Smithsonian Institution
Revitalization of the Historic Core
Smithsonian Institution Building -
The Castle

Commission of Fine Arts
REVISED CONCEPT SUBMISSION

September 15, 2022

EYP-Loring, LLC

Figure 3.1.1.x - Proposed Jefferson Drive perimeter security: building entrance protection with security as furniture.

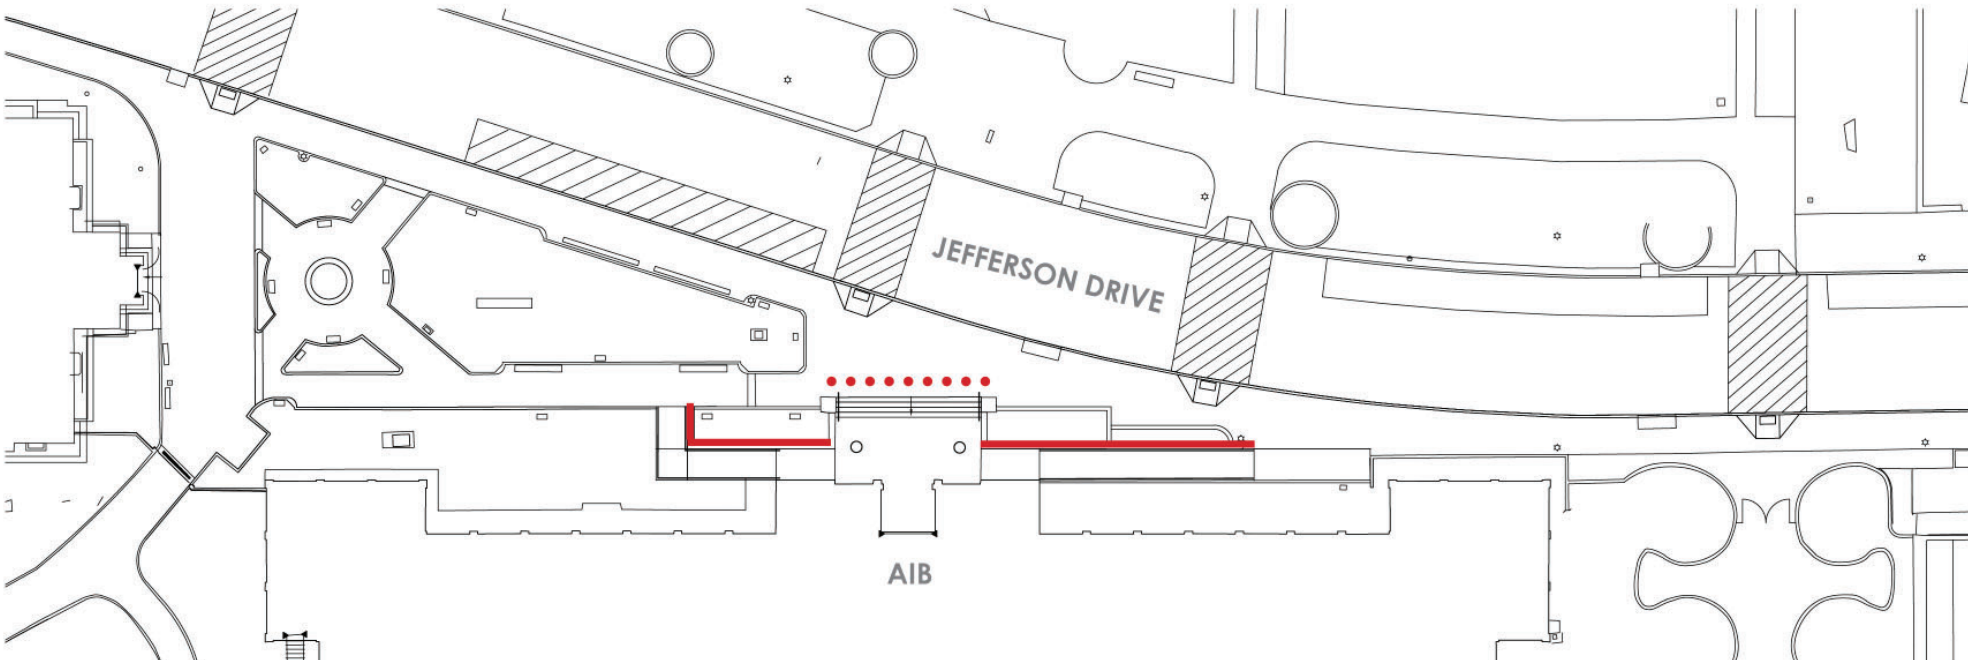
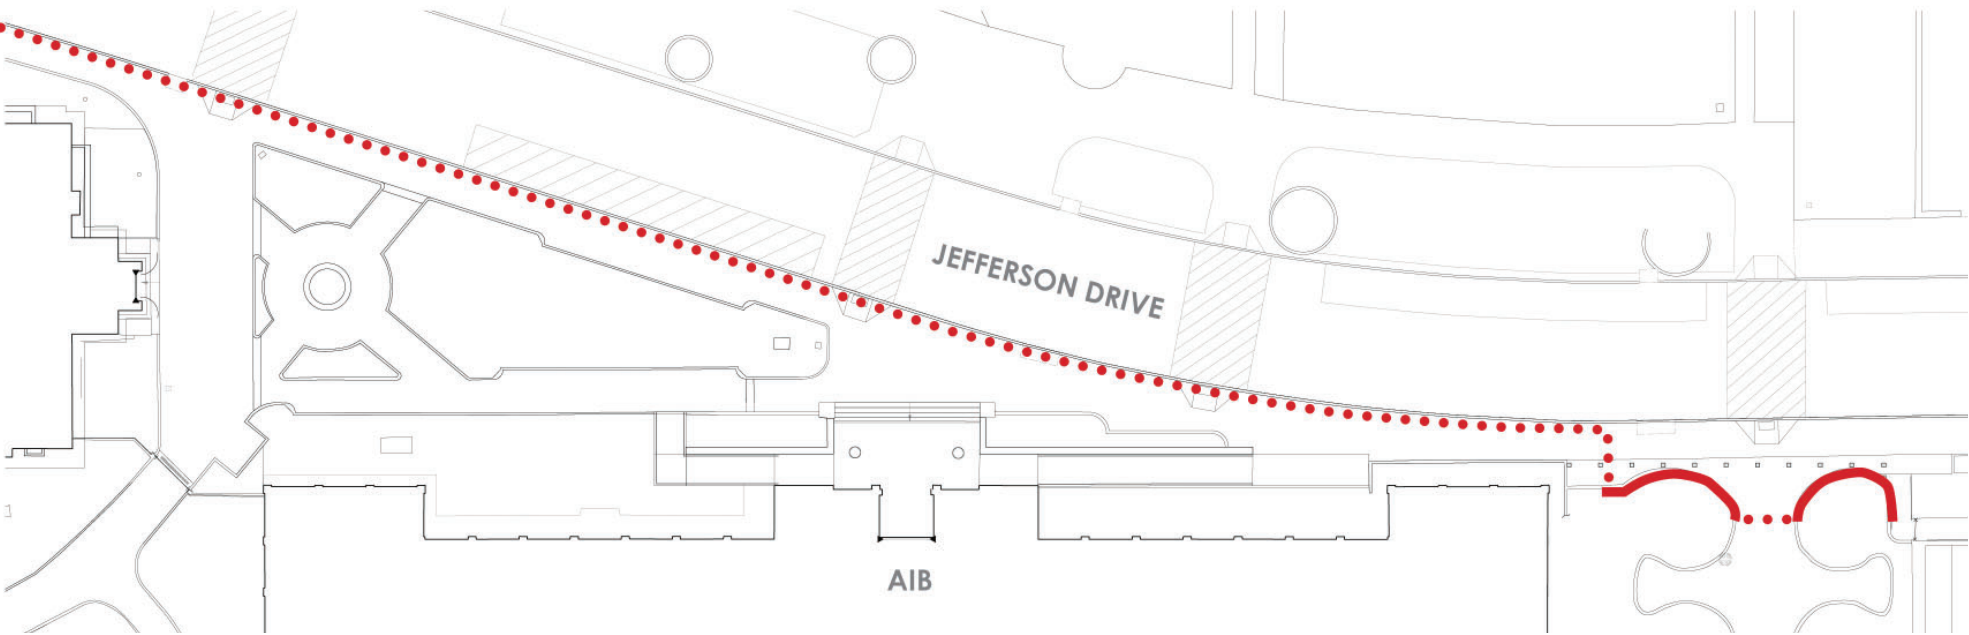
As shown in Figure 3.1.1.y, a previous version of the plan called for a continuous row of bollards to be located along the Jefferson Drive curb.

Along Jefferson Drive in front of the Arts and Industries Building (AIB), a combination of fixed and retractable bollards and low stone walls with hardened grilles will be employed (Figure 3.1.1.x). At the pedestrian entry to the Ripley Garden, pedestrian gates will provide additional security.

Figure 3.3.1.a - Previous design, visualization of southeast roof. Existing elevator penthouse to be removed (shown in dashed red lines).

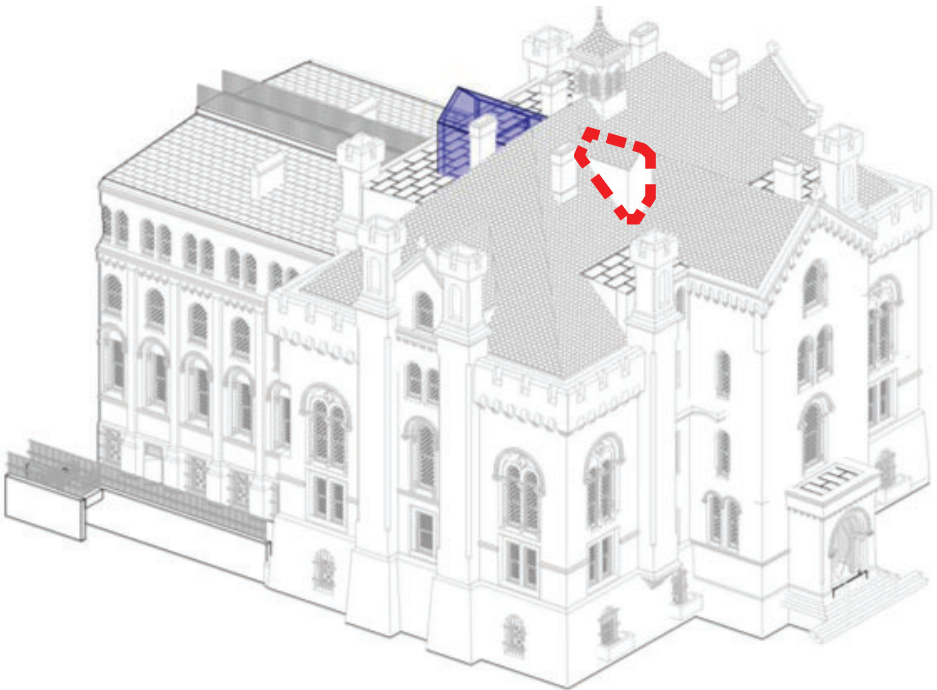
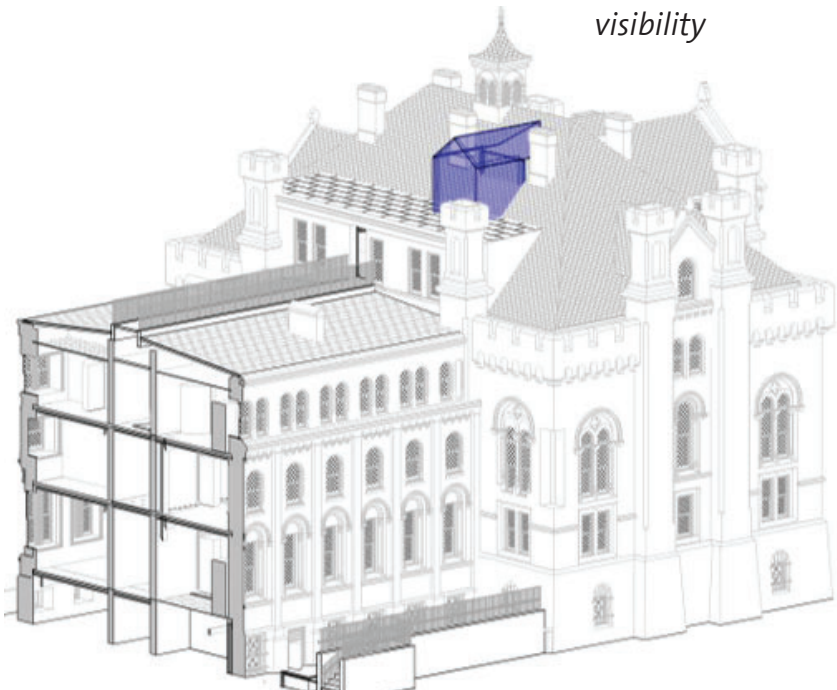
The previous proposal placed the elevator penthouse on the west side of the east wing. This penthouse was determined through Section 106 consultation to have an adverse effect from its visibility and impacts to the east wing decorative roofscape.

In response to comments received from the Commission and Consulting Parties the design for the elevator in the East Wing of the Castle has been revised. In coordination with staff at the Smithsonian Institution an alternate type of elevator was studied which requires less overrun space. While this is not the standard type of elevator used in Smithsonian facilities it was accepted in this location to minimize exterior visual impacts to the Castle. Utilizing this alternate type of elevator will result in no rooftop penthouse, as illustrated in Section 3.3.1.

Figure 3.3.1.h - Revised design, visualization of southeast roof. Existing elevator penthouse to be removed (shown in dashed red lines).

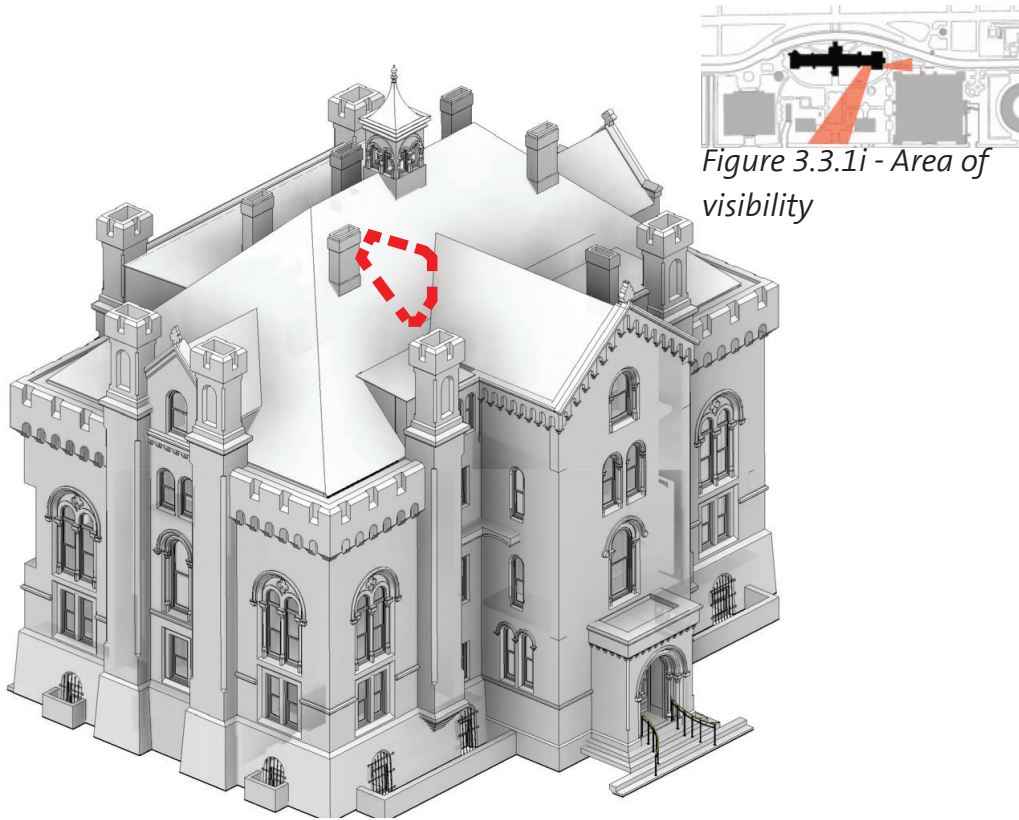
A revised design limited the elevator overrun to a small eyebrow dormer projection on the south side of the east wing roof. This minor projection would still be visible from within the Haupt Garden and from the west but had less visual impact than the previous design.

Utilizing an alternate type of elevator that requires less space above the elevator or overrun was studied with the Smithsonian facilities team. This type of elevator, referred to as a “Machine-Room-Less” (MRL) elevator, will be utilized in this location due to the historic preservation sensitivities of the Castle. No rooftop penthouse will be required. The existing elevator penthouse on the east side of the East Wing roof will be removed and the historic roofline restored.
